## Product Change Notification

### PCN-IFC-706-2017

| Business Unit                       | Product Line Code | Type of Change              | Action                        | Date of Issue |
|-------------------------------------|-------------------|-----------------------------|-------------------------------|---------------|
| IFC - Industrial Field Connectivity | BF7               | Product Change Notification | Notify Distributors and Field | 6/13/2017     |

#### Description for Product Change Notification

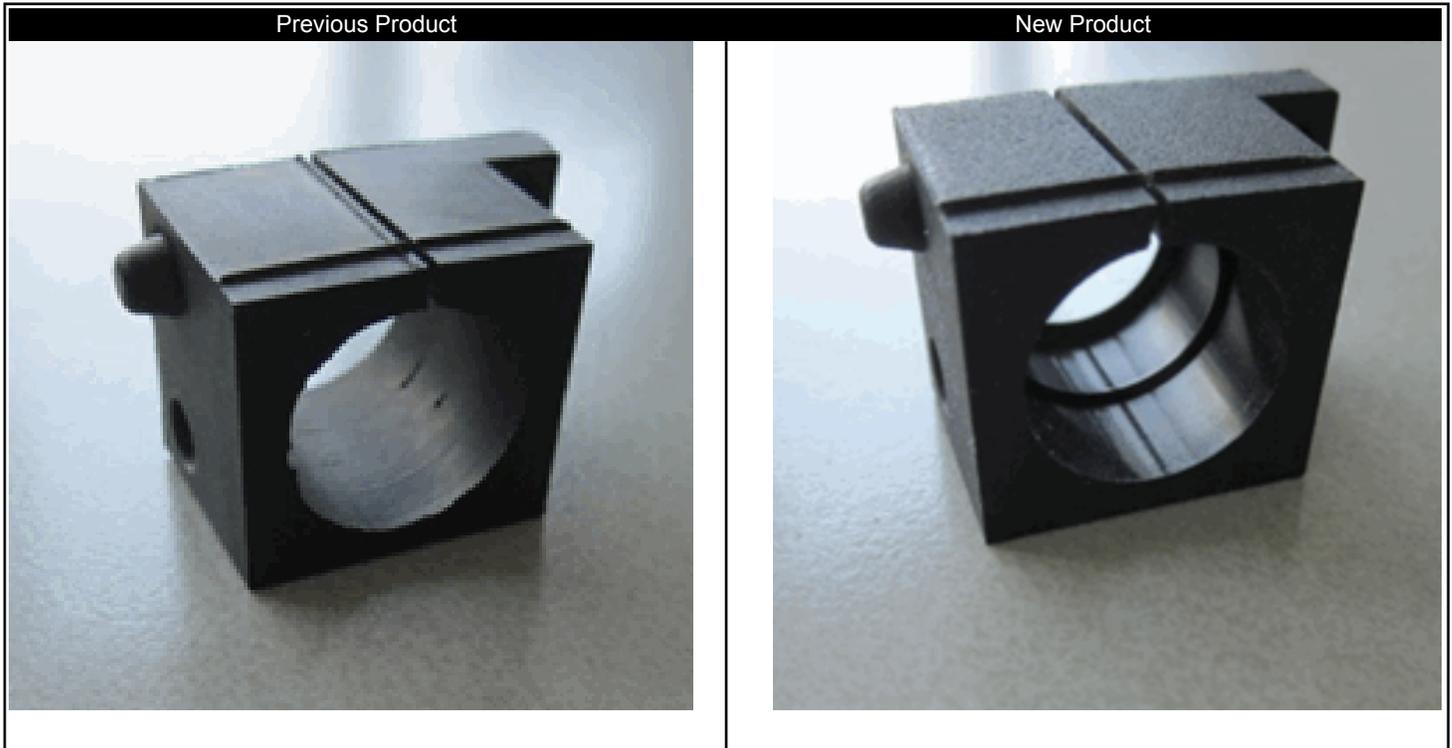
Additional lips are being added to the cable entry point for several CES cable sleeve modules. This modification is an improvement on our method of achieving the IP54 rating.
